SECTION 00 91 15

ADDENDUM NUMBER 6

- 1.01 DATE: JANUARY 22, 2021**
- 1.02 PROJECT: ELMORE SPORTS MEDICINE RENOVATIONS**
- 1.03 PROJECT NUMBER: DCM NO. 2020452; PSCA NO. 2018**
- 1.04 OWNER: ALABAMA A&M UNIVERSITY**
- 1.05 ARCHITECT: NOLA | VAN PEURSEM ARCHITECTS, PC**

SHEET NUMBER
M-1
OF
4

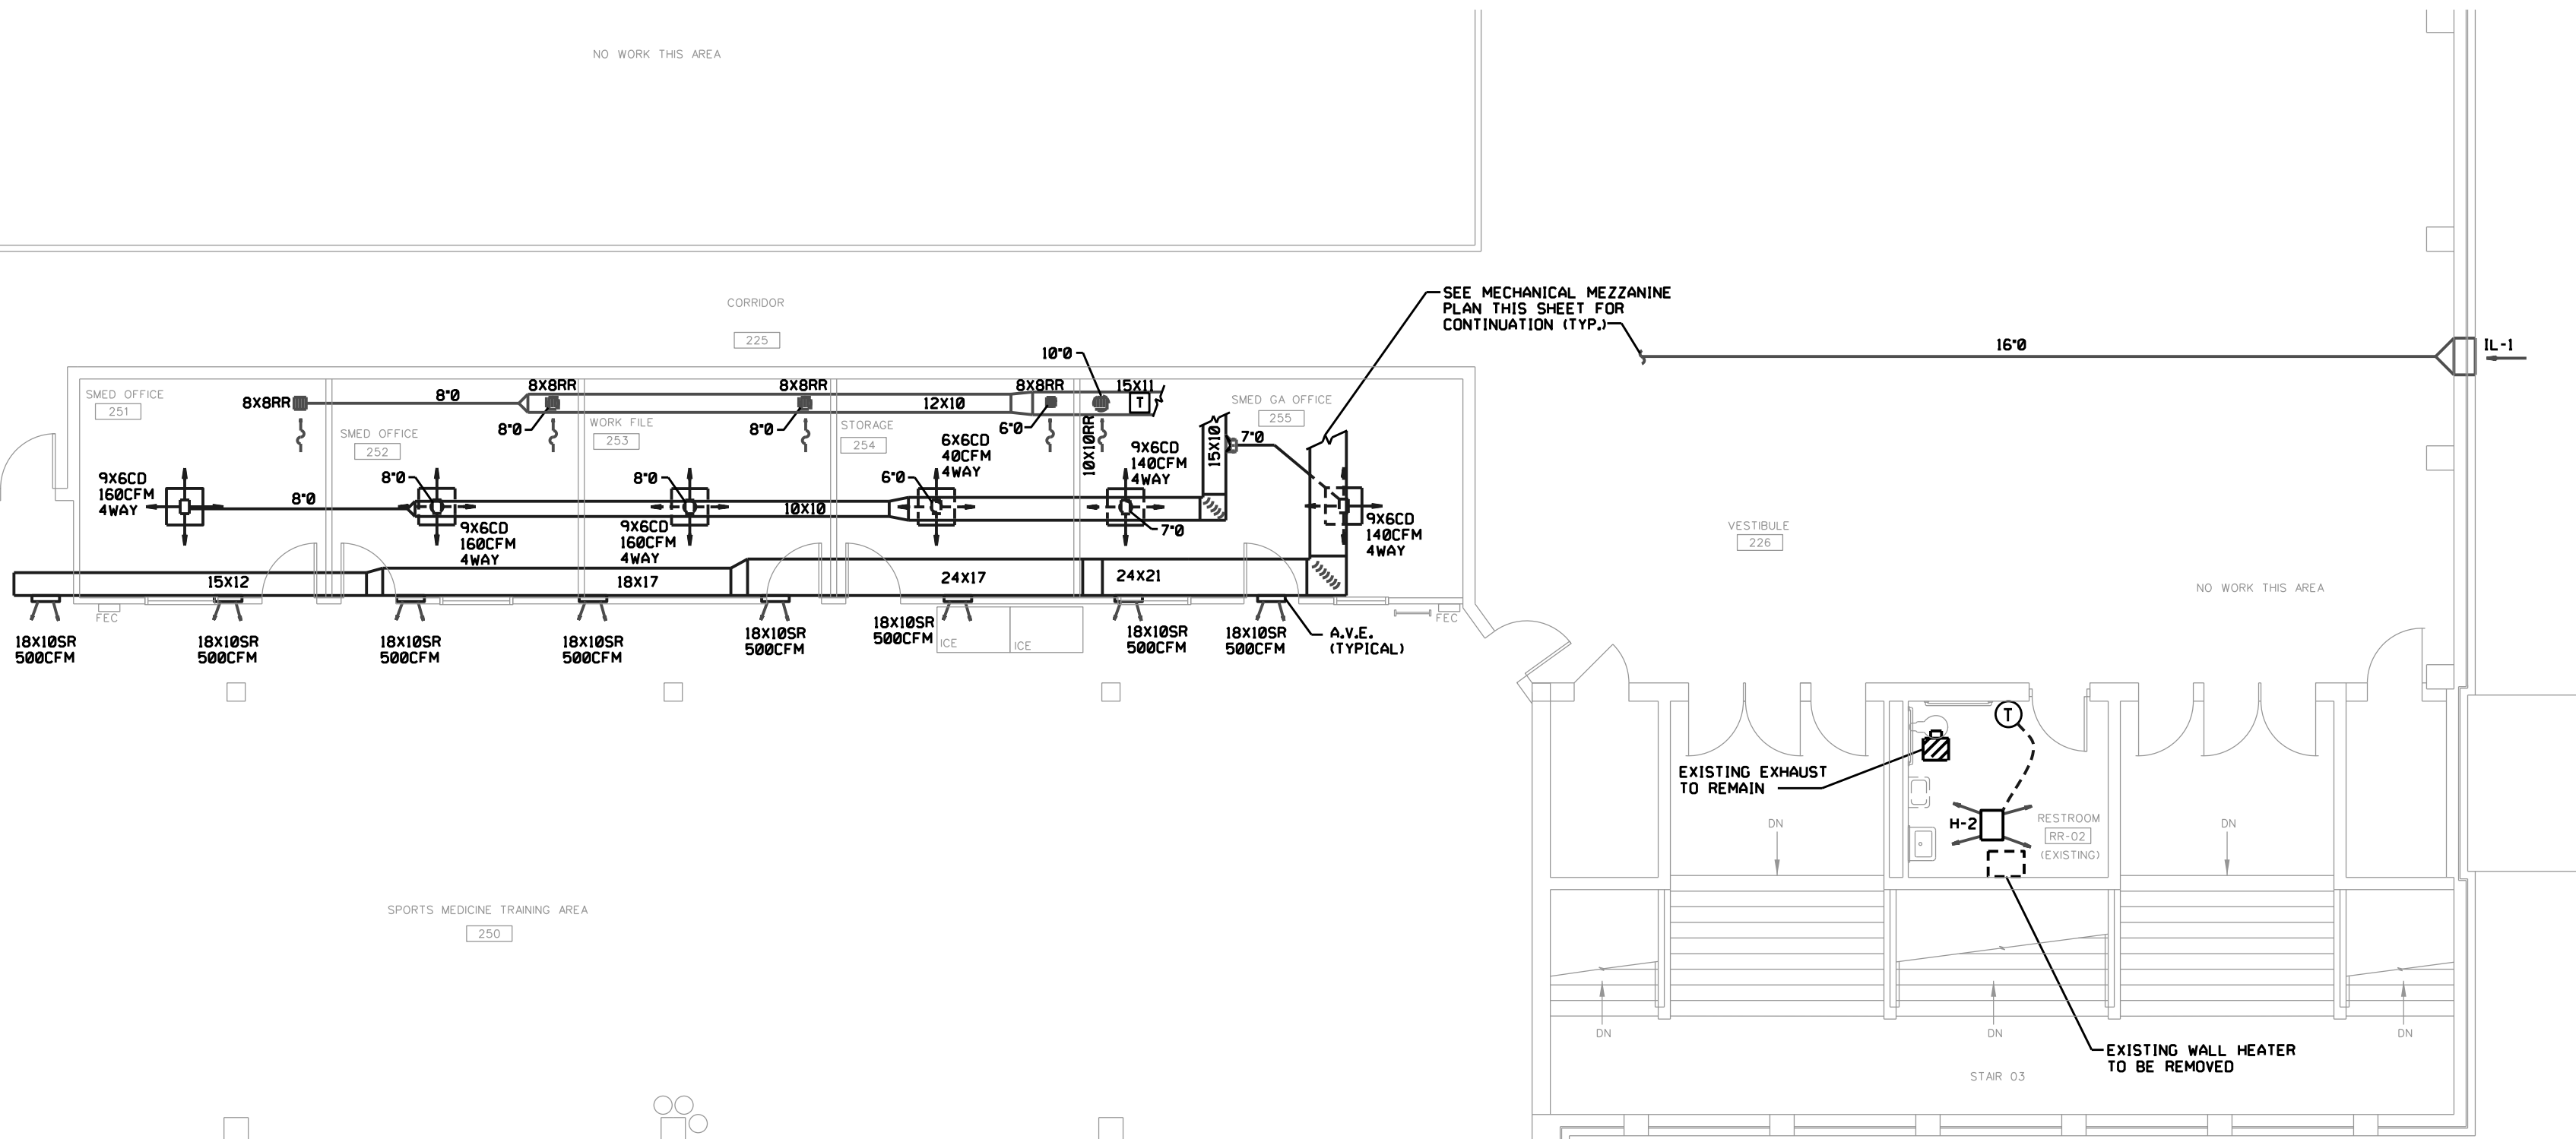
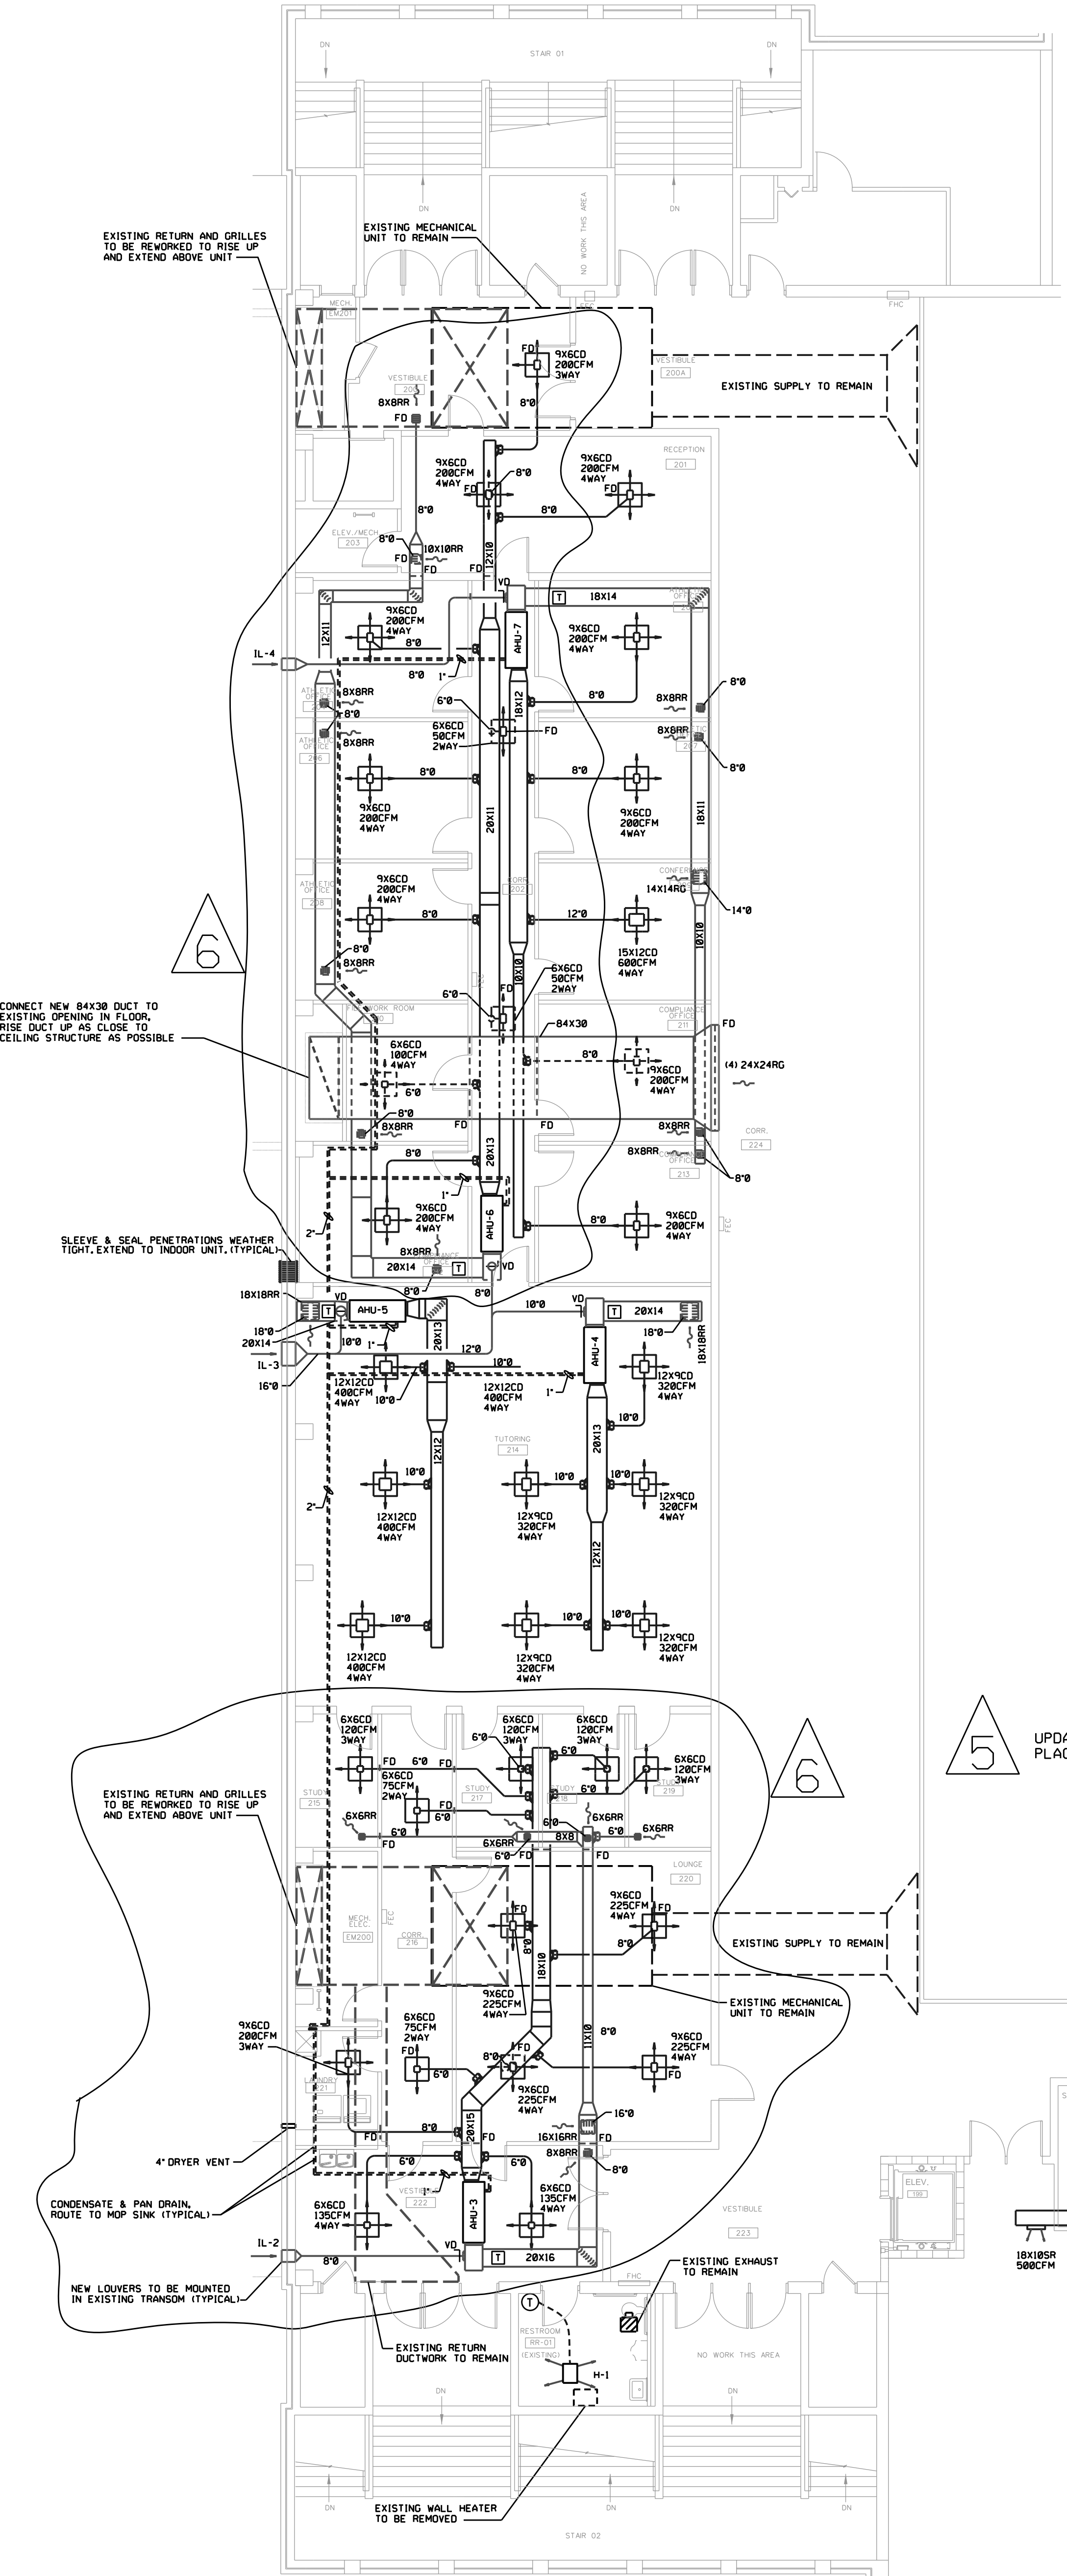
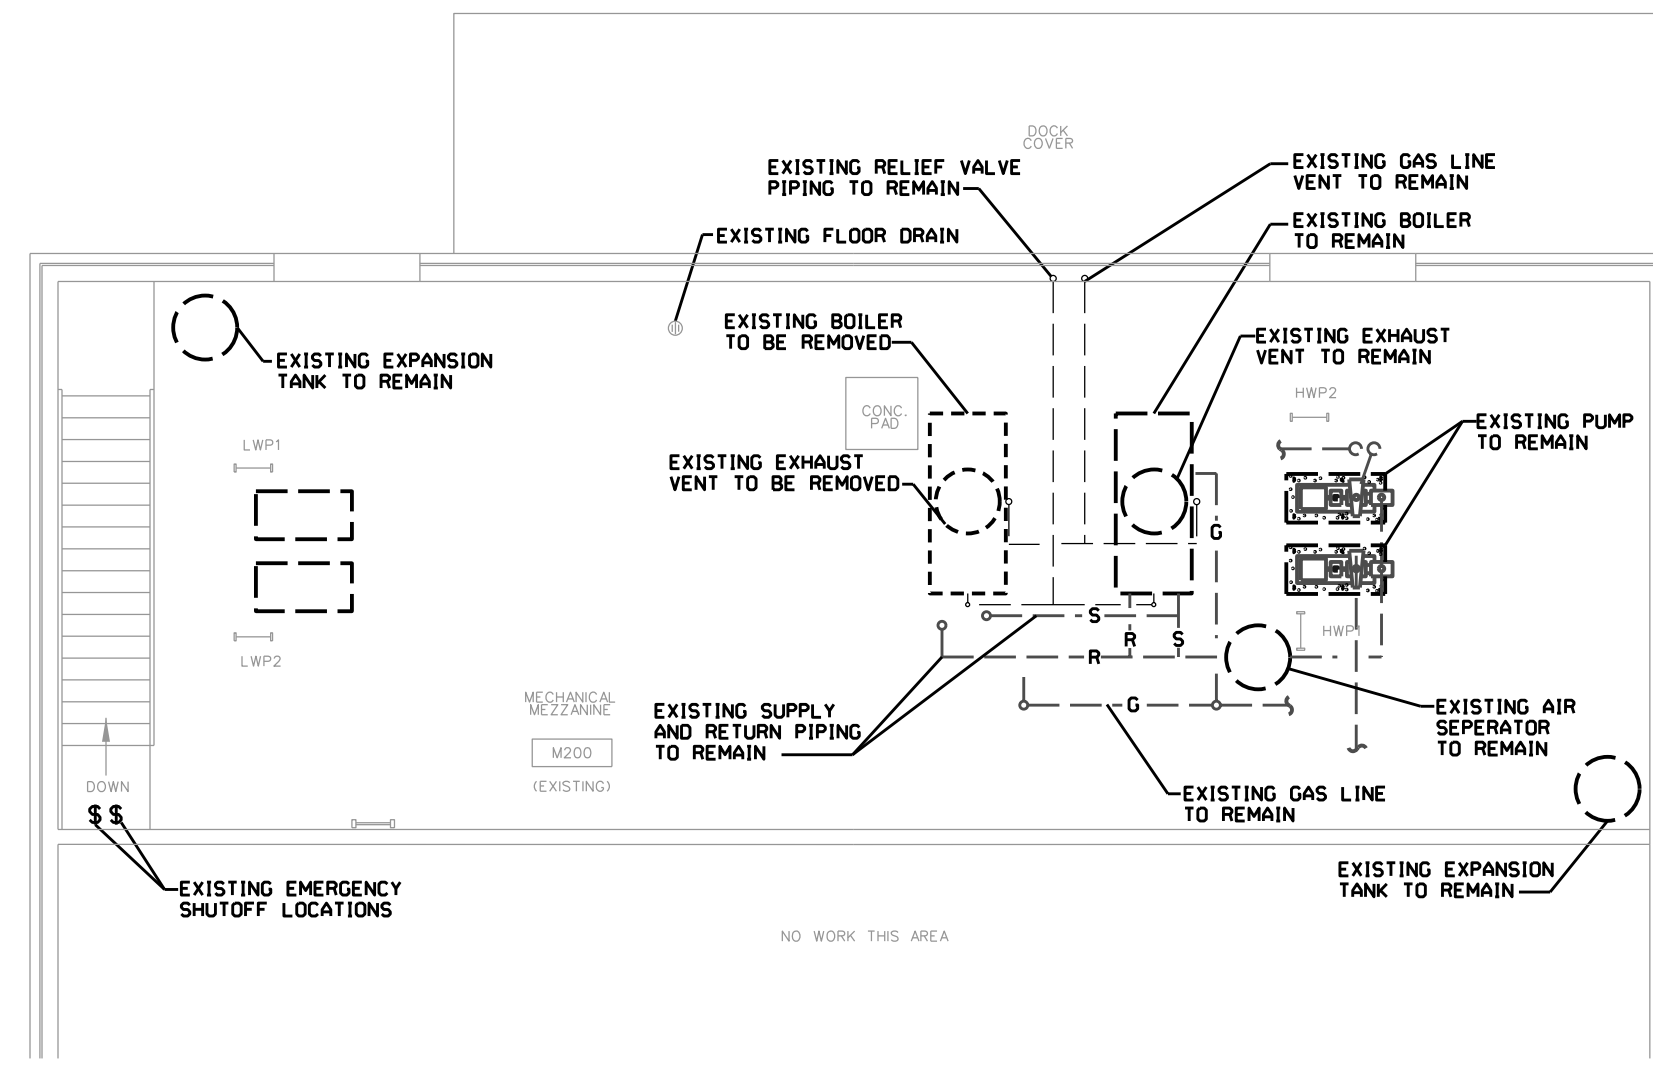
- A. Replace this sheet in its entirety. Revisions include the following:
 1. Revisions to the duct layout & fire damper locations on the Partial Mezzanine Plan
